Access Compliance Report

Public Rights-of-Way

Intersection ID: 4943	Main Street: ICON_WY	Cross Street: LAWNMEADOW_DR	Location: NW
ADA ID: 10CE3F4B2E78	Ramp Type: BlendTrans1	Initial Pass/Fail: Fail	Overall Compliance: No
		Severity Score: 12.5

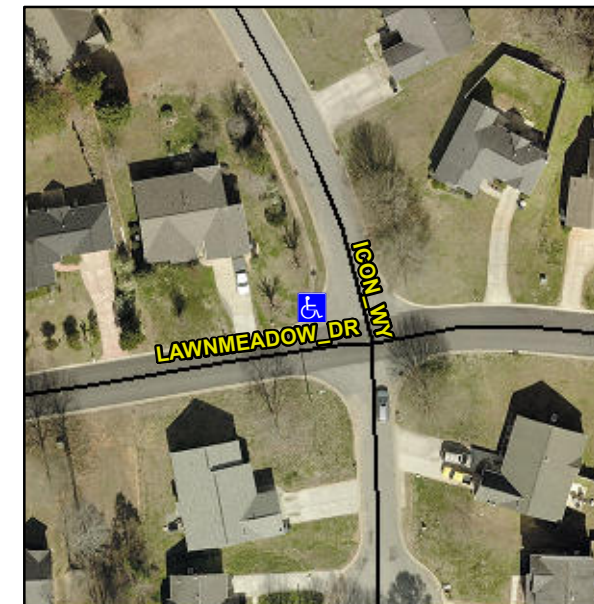
NO LT SW

R304.5.3

Compliance	Description	Data	Compliance	Description	Data
N/A	Ramp Length (in)	50.0	Yes	BlendTrans Slope (%)	3.3
Yes	Ramp Width (in)	48.0	No	BlendTrans XSlope (%)	5.6
N/A	Flare Type LT	N/A	N/A	Flare Type RT	N/A
N/A	Flare Slope LT (%)	N/A	N/A	Flare Slope RT (%)	N/A
N/A	Flare Traversable LT?	N/A	N/A	Flare Traversable RT?	N/A
N/A	Landing Length (in)	N/A	N/A	DWS Provided?	N/A
N/A	Landing Width (in)	N/A	N/A	DWS Contrast?	N/A
N/A	Landing Slope (%)	N/A	N/A	DWS Length (in)	N/A
N/A	Landing X Slope (%)	N/A	N/A	DWS Full Width?	N/A
N/A	Landing Curb? (Y/N)	N/A	N/A	DWS Offset (in)	N/A
N/A	Shared Landing?	N/A			
N/A	Gutter Ponding?	N/A	N/A	Gutter Slope (%)	N/A
N/A	Gutter Lip Ht (in)	N/A	N/A	Gutter X Slope (%)	N/A
N/A	Painted X Walk1?	No	N/A	Painted X Walk2?	No
	X Walk 1 Direction	To S		X Walk 2 Direction	To E
	X Walk 1 Width (in)	N/A		X Walk 2 Width (in)	N/A
	X Walk 1 Slope (%)	2.3		X Walk 2 Slope (%)	N/A
	X Walk 1 X Slope (%)	5.0		X Walk 2 X Slope (%)	N/A

Remove & Replace Curb Ramp With Two New Directional Ramps or Equivalent.
